Access Compliance Report

Public Rights-of-Way

(Curb Ramps)

Intersection ID: 6149	Main Street: STATESVILLE_RD	Cross Street: SUNTRACE_WY	Location: SW
ADA ID: 766D18F273C9	Ramp Type: Perp	Initial Pass/Fail: Fail	Overall Compliance: No
Severity Score: 8.75			
Codes/Mitigation Info/Possible Solution		Field Measurements/Component Compliance

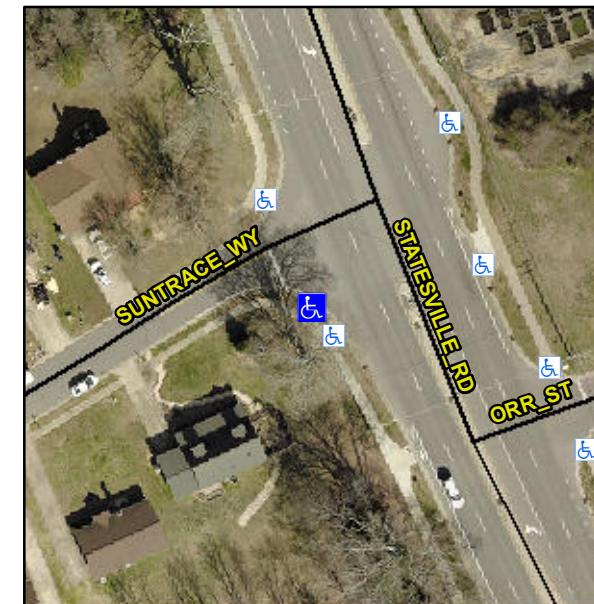
Not Found, R304.5.1

Compliance	Description	Data	Compliance	Description	Data
N/A	Ramp Length (in)	73.5	Yes	Ramp Slope (%)	7.5
No	Ramp Width (in)	46.0	Yes	Ramp XSlope (%)	1.4
N/A	Flare Type LT	N/A	N/A	Flare Type RT	N/A
N/A	Flare Slope LT (%)	N/A	N/A	Flare Slope RT (%)	N/A
N/A	Flare Traversable LT?	N/A	N/A	Flare Traversable RT?	N/A
N/A	Landing Length (in)	N/A	N/A	DWS Provided?	N/A
N/A	Landing Width (in)	N/A	N/A	DWS Contrast?	N/A
N/A	Landing Slope (%)	N/A	N/A	DWS Length (in)	N/A
N/A	Landing X Slope (%)	N/A	N/A	DWS Full Width?	N/A
N/A	Landing Curb? (Y/N)	N/A	N/A	DWS Offset (in)	N/A
N/A	Shared Landing?	N/A			
N/A	Gutter Ponding?	N/A	N/A	Gutter Slope (%)	N/A
N/A	Gutter Lip Ht (in)	N/A	N/A	Gutter X Slope (%)	N/A
N/A	Painted X Walk1?	No	N/A	Painted X Walk2?	N/A
	X Walk 1 Direction	To N		X Walk 2 Direction	N/A
N/A	X Walk 1 Width (in)	N/A	N/A	X Walk 2 Width (in)	N/A
	X Walk 1 Slope (%)	0.4		X Walk 2 Slope (%)	N/A
	X Walk 1 X Slope (%)	2.6		X Walk 2 X Slope (%)	N/A

Remove & Replace Entire Ramp.
